Access Compliance Report Public Rights-of-Way (Curb Ramps)

Main Street: CHADBOURNE_LN Cross Street: GLENMERE_DR Location: NE

ADA ID: RPRK211008133806 Ramp Type: Type 1 - Perpendicular Diagonal Initial Pass/Fail: Fail Overall Compliance: No Severity Score: 45

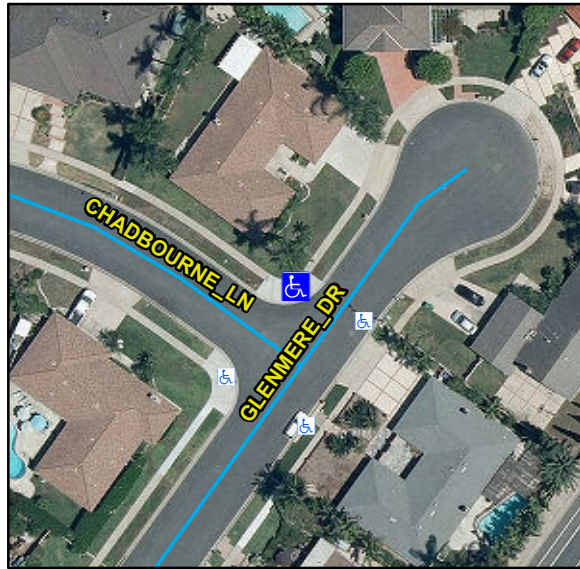
Compliance	Description	Data	Compliance	Description	Data
N/A	Ramp Length (in)	135	N/A	Flare Type LT	
Yes	Ramp Width (in)	48			N/A
No	Ramp Run Slope (%)	12.3	N/A	Flare Slope LT (%)	N/A
No	Ramp Cross Slope (%)	5.2	N/A	Flare Traversable LT	N/A
N/A	Landing Present	N/A	N/A	Flare Type RT	
N/A	Landing Length (in)	N/A			N/A
N/A	Landing Width (in)	N/A	N/A	Flare Slope RT (%)	N/A
N/A	Landing Run Slope (%)	N/A	N/A	Flare Traversable RT	N/A
N/A	Landing Cross Slope (%)	N/A	N/A	DWS Provided	N/A
N/A	Landing Movement Obstructed?	N/A	N/A	DWS Contrast	N/A
	Landing Movement Type	N/A	N/A	DWS Length (in)	N/A
N/A	Landing Shared	N/A	N/A	DWS Full Width	N/A
N/A	Clear Space	Yes	N/A	DWS Offset Left (in)	N/A
N/A	Clear Space To Crosswalk (in)	N/A	N/A	DWS Offset Right (in)	N/A
N/A	Marked Crosswalk 1	No	N/A	Marked Crosswalk 2	No
	Crossing 1 Direction	W		Crossing 2 Direction	S
	Marked Crosswalk 1 Width (in)	N/A		Marked Crosswalk 2 Width (in)	N/A

N/A	Ramp Inside Crosswalk 1	N/A	Yes	Ramp Inside Crosswalk 2	N/A
	Crossing 1 Slope (%)	7.9		Crossing 2 Slope (%)	0.7
	Crossing 1 Cross Slope (%)	1.8		Crossing 2 Cross Slope (%)	0.3
N/A	Gutter Ponding	N/A	No	Curb Slope	13.5
Yes	Gutter Lip Height (in)	0		Road Run Slope (%)	0.8
N/A	Gutter Run Slope (%)	N/A		Road Cross Slope (%)	0.6
N/A	Gutter Cross Slope (%)	N/A			
Yes	Overall Surface Condition: Acceptable		Yes	Perp Joint Present	Yes
	Cross Gutter Present?	No		Spandrel Present?	No
	Replace Cross Gutter?	N/A		Replace Spandrel?	N/A

Remove & Replace Curb Ramp With Two New Directional Ramps or Equivalent.

R304.2.2, R304.5.3, STD 1115
